**PLANNED UNIT DEVELOPMENT
& SUBDIVISION STAFF REPORT****Date: May 15, 2014****DEVELOPMENT NAME**

L.C. Miller Subdivision

LOCATION7900 & 7908 Airport Boulevard
(North side of Airport Boulevard, 560'± West of
Schillinger Road South)**CITY COUNCIL
DISTRICT**

AREA OF PROPERTY2 Lots / 3.4 ± acres (Subdivision)
1 Lot / 3.1 ± acres (PUD)**CONTEMPLATED USE**Planned Unit Development Approval to allow multiple
buildings on a single building site, and Subdivision approval to create 2 lots.**TIME SCHEDULE
FOR DEVELOPMENT**

SITE PLAN

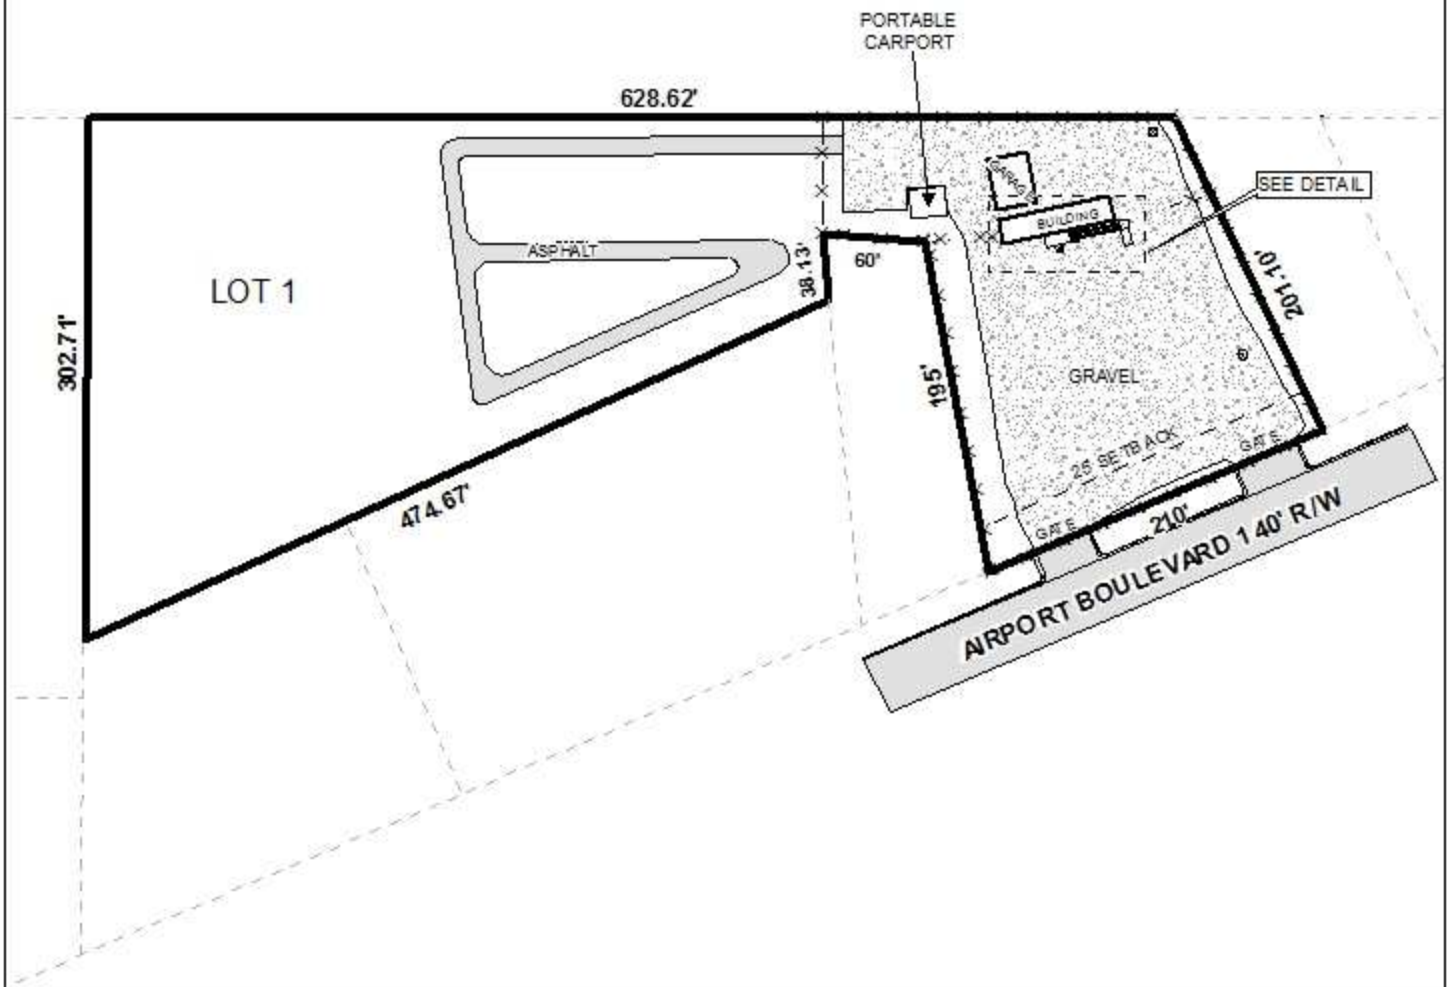
The site is covered primarily in gravel, however, there is a large area to the west that is surfaced in what appears to be grass (staff cannot determine if gravel ever existing in this area). As the existing surfacing is a non-conforming situation existing prior to annexation into the City, there should be no requirement to provide asphalt or concrete paving, with the only exception being as it relates to accessible parking. The applicant should be required to provide one van accessible parking space with access aisle, paved in asphalt or concrete, and connected by a compliant paved surface to the accessible ramp.

Otherwise, no improvements are proposed for the non-compliant site: no trees or landscape improvements are proposed, nor are any lighting or parking area improvements indicated. It should be noted that full compliance with all aspects of the Zoning Ordinance will be required if the site is redeveloped.

It should be noted that it appears that the freestanding sign for the auto sales business is located within the right-of-way of Airport Boulevard. The sign should be relocated, with the appropriate sign permit, to be on private property, setback at least 18 inches from the right-of-way.

A dumpster is depicted on the site plan and is visible in 2010 aerial photos. Staff cannot determine if the dumpster existed prior to 2010. If any additional dumpsters are added to the site, they must be placed in compliance with the current requirements of Section 64-4.D.9. of the Zoning Ordinance.

- 7) Provision of one van accessible parking space and access aisle, paved in asphalt or concrete, next to the proposed accessible ramp into the office, with appropriate signage, by obtaining a land disturbance permit prior to the signing of the final plat;

- 8) Relocation of the existing freestanding sign to be located a minimum of 18 inches inside the right-of-way line, on private property, including the obtaining of a sign permit prior to the signing of the final plat;
